Project	IEEE 802.16 Broadband Wireless Access Working Group < <a href="http://ieee802.org/16">http://ieee802.org/16</a> >	
Title	In-band Transparent Relay Frame Structure	
Date Submitted	2006-03-14	
Source(s)	<p>Kanchei (Ken) Loa, Yi-Hsueh Tsai, Yung-Ting Lee, Heng-Iang Hsu Shiann-Tsong Sheu, Frank C.D. Tsai, Youn-Tai Lee, Chih-Chiang Hsieh, Hua-Chiang Yin, Institute for Information Industry 8F., No. 218, Sec. 2, Dunhua S. Rd., Taipei City, Taiwan.</p> <p>Gang Shen, Kaibin Zhang Alcatel-Lucent, Research &amp; Innovation 388#, Ningqiao Road, Shanghai, China.</p> <p>[add co-authors here]</p>	<p>Voice: +886-2-2739-9616 <a href="mailto:loa@iii.org.tw">loa@iii.org.tw</a></p> <p><a href="mailto:gang.a.shen@alcatel-sbell.com.cn">gang.a.shen@alcatel-sbell.com.cn</a></p>
Re:	IEEE 802.16j-07/007r2: "Call for Technical Comments and Contributions regarding IEEE Project 802.16j"	
Abstract	This contribution proposes in-band transparent relay frame structure

## In-band Transparent Relay Frame Structure

Figure yyy Example of configuration for an in-band transparent relay frame structure

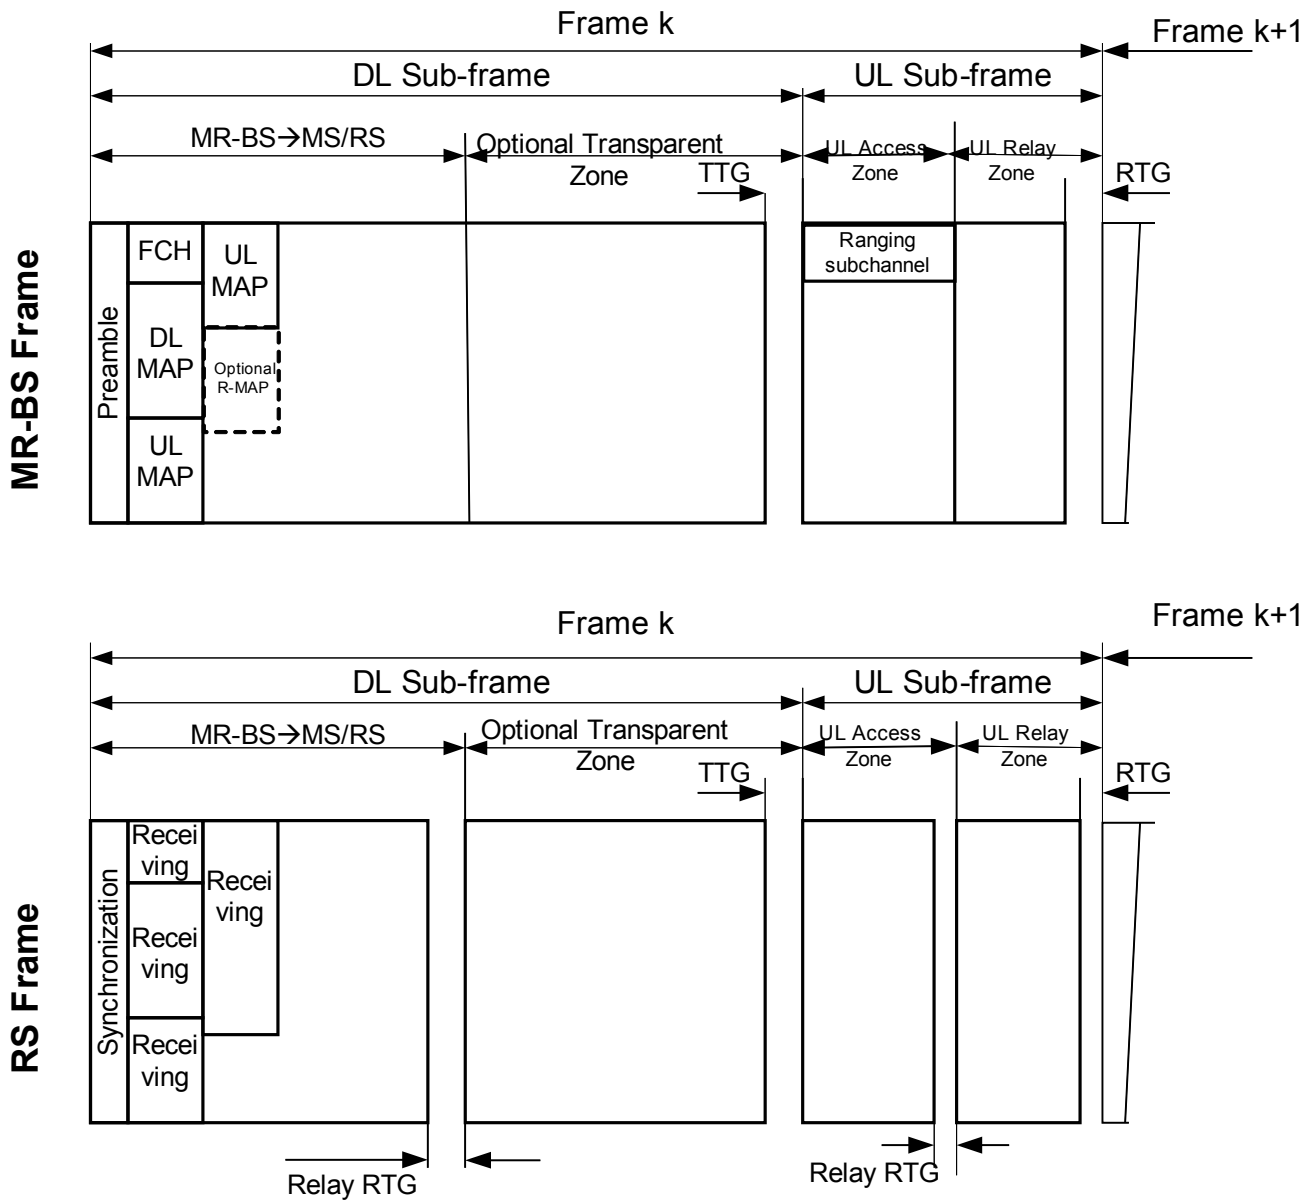
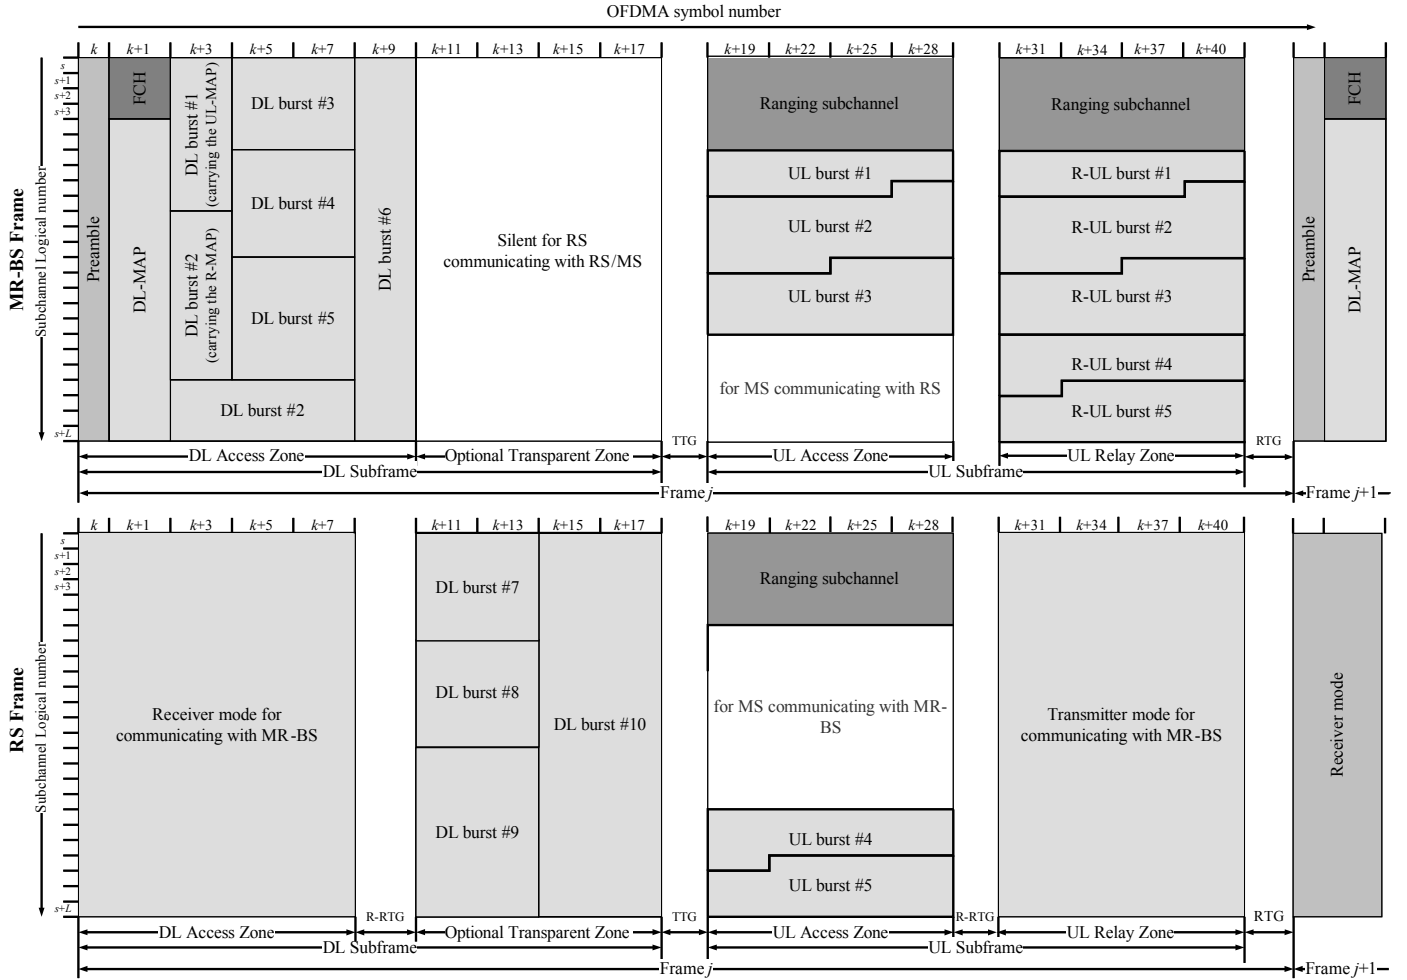
*[Change the figure in section 8.4.4.7.1 “Frame structure for transparent mode” as indicated:]*

*[Replace Figure xxx with Figure yyy as follows:]*
